TERREBONNE PARISH COUNCIL

PUBLIC SERVICES COMMITTEE

AGENDA

January 23, 2017
5:30 PM

MULTI-AGENCY SAFE ROOM
105 GOVERNMENT STREET
TERREBONNE PARISH, LOUISIANA

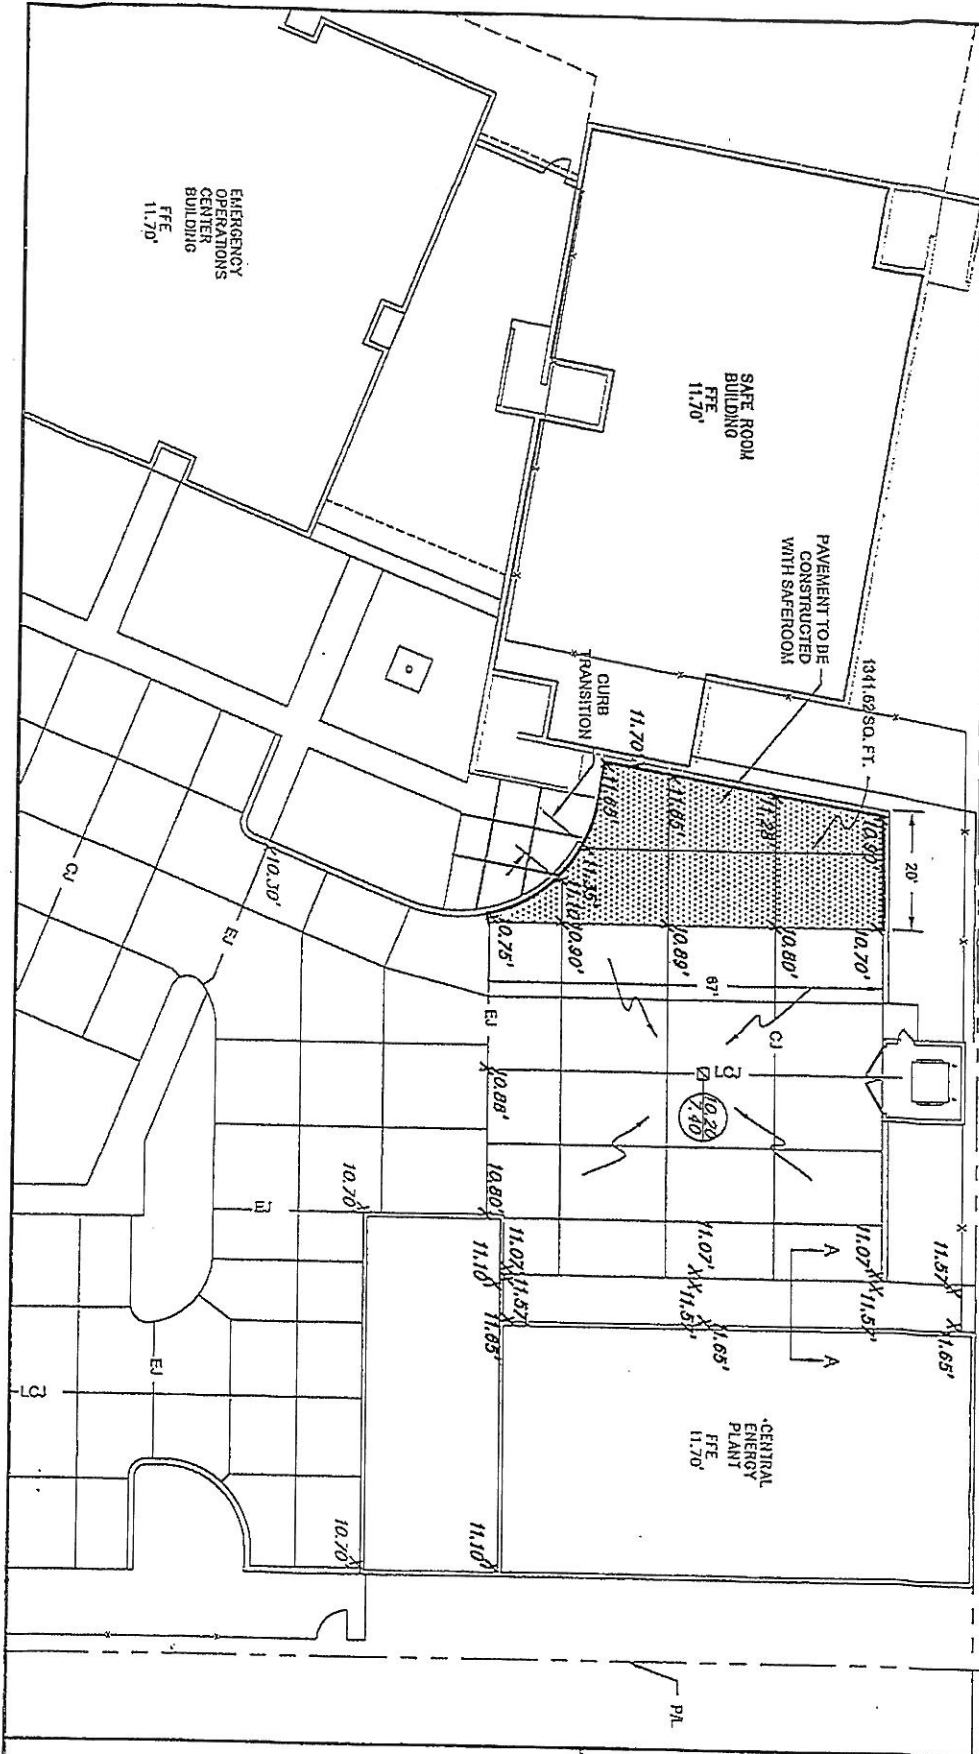
PROJECT PURPOSE & BENEFITS (150 WORDS OR LESS)
Change Order No. 9 consists of a credit to delete the portion of concrete paving adjacent to the future safe room. The change order also adds fourteen (14) days to the construction contract due to change order work and adverse weather in the month of September and November.

Please provide credit to delete the portion of concrete paving adjacent to the future Safe Room and adjust the elevations as per the attached sketch.

WHEREAS, this change order will decrease the overall contract price by Seven Hundred and Seventy-Three Dollars and Ninety-Five Cents (\$773.95), and

WHEREAS, this change order will add fourteen (14) calendar days to the contract as a result of Change Order No. 9, and
